Sun Visor May Move from the Stowed Position

YEAR(S)	MODEL(S)	ADDITIONAL INFORMATION
2010 - 2013	Highlander	WMI(s): 5TD Plant Code(s): S

REVISION NOTICE

Figure 1.

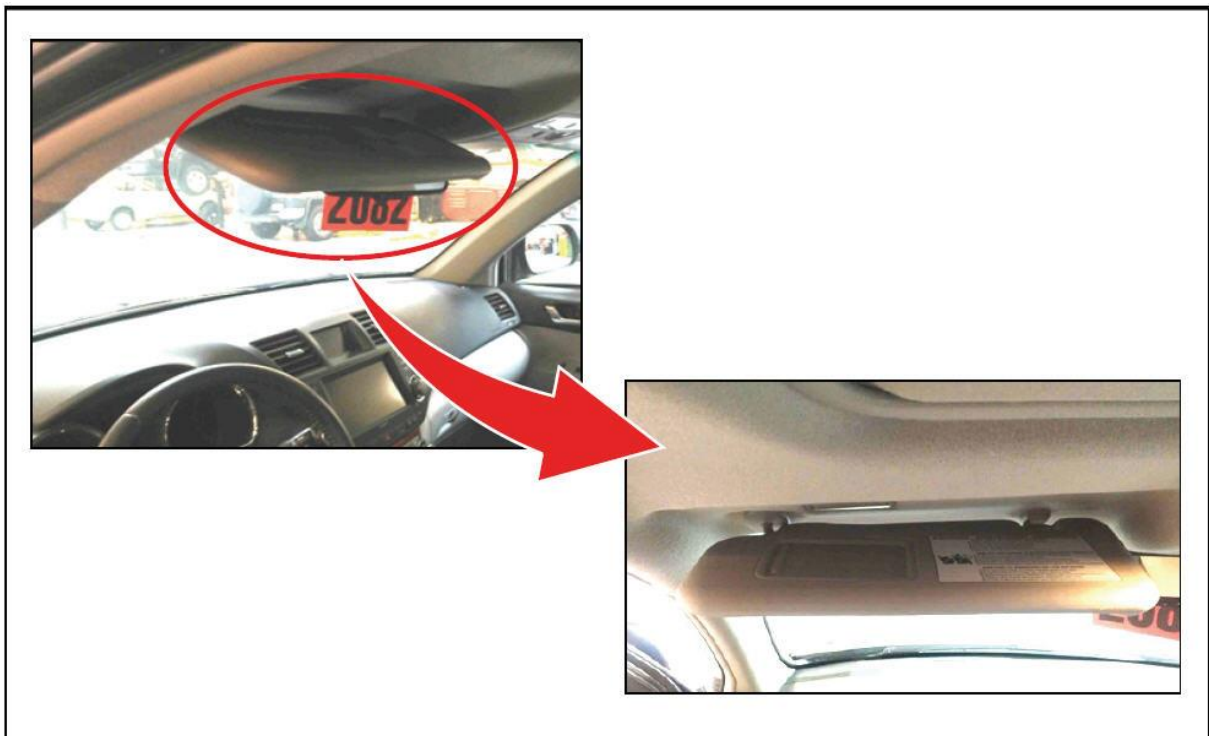
Some 2010 – 2013 model year Highlander vehicles may exhibit a condition in which the driver side or passenger side Sun Visor may move from the stowed position, or may not completely stow flush against the headliner. Follow the Repair Procedure in this bulletin to address this concern.

1. Confirm the condition described in the Introduction is present.
2. Replace the Sun Visor.
Refer to the Technical Information System (TIS), applicable model and model year Repair Manual:
 - 2010 Highlander:
Vehicle Interior – Interior Panels/Trim – “Interior: Roof Headlining: [Removal/Installation](#)”
 - 2011 Highlander:
Vehicle Interior – Interior Panels/Trim – “Interior: Roof Headlining: [Removal/Installation](#)”
 - 2012 Highlander:
Vehicle Interior – Interior Panels/Trim – “Interior: Roof Headlining: [Removal/Installation](#)”
 - 2013 Highlander:
Vehicle Interior – Interior Panels/Trim – “Interior: Roof Headlining: [Removal/Installation](#)”
3. Confirm condition is no longer present.
